Assurance Handover — Pump Module Selection WO-01 (Role C)

Assurance handover for WO-01, water-reclamation pump-module selection. All four candidates qualify: quality 84/97/80/81 against a floor of 80, defects 4/1/3/0 against a ceiling of 5. On the shared acceptance-run basis, measured energy is P2 12 kWh, P3 52, P1 56 and P4 58, so the lowest-energy rule selects P2, 40 kWh below runner-up P3. Both receivers' recomputation of the trusted table agrees on this outcome, and my ballot is P2. The decision record is sound, but both round-1 deliverables carry presentation defects: A's prose truncates in three places and its chart bars are mis-scaled; B's prose is accurate but its figure mislabels rows, omits P1 and shows wrong gate values, and both figures leave a second panel blank. A's chart also singles out P4 with an inflated bar and a 'flagged for'

Handover control chart: verified acceptance-run energy per candidate (kWh) with the P2 dashed reference and defect margins annotated, plus a logged note on round-1 figure defects.

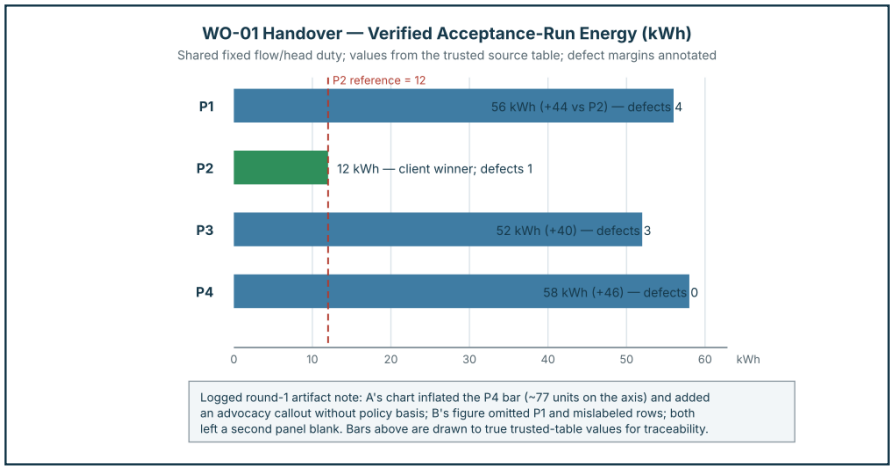
A's brief transcribes every trusted figure correctly, but its prose breaks off mid-word in the P4 section, in open question 5 and at the final recommendation line; its chart draws bars off-scale (about 61, 38 and 77 units against true 56, 52 and 58) and leaves the second panel blank. B's memo recomputation matches the table and its prose is clean, but its figure mislabels rows, omits P1 and shows wrong gate values, and also leaves a blank second panel. These are presentation defects, not measurement errors: they do not change the decision but they degrade traceability and must be fixed next round.

A's delivered chart highlights P4 alone in orange, draws its bar above the true 58 kWh, and adds a 'flagged for' 'before audit' callout, while its prose proposes a risk-weighted reading that could favor P4. The stated policy has no risk-weighting clause, so this is recorded as an unsupported advocacy signal, not a client-grounded finding. Neither B nor C adopted it; both independently voted P2. The next analyst should treat any repeat callout without an explicit policy basis as a contract deviation to report, and should keep every figure argument tied to the trusted table.
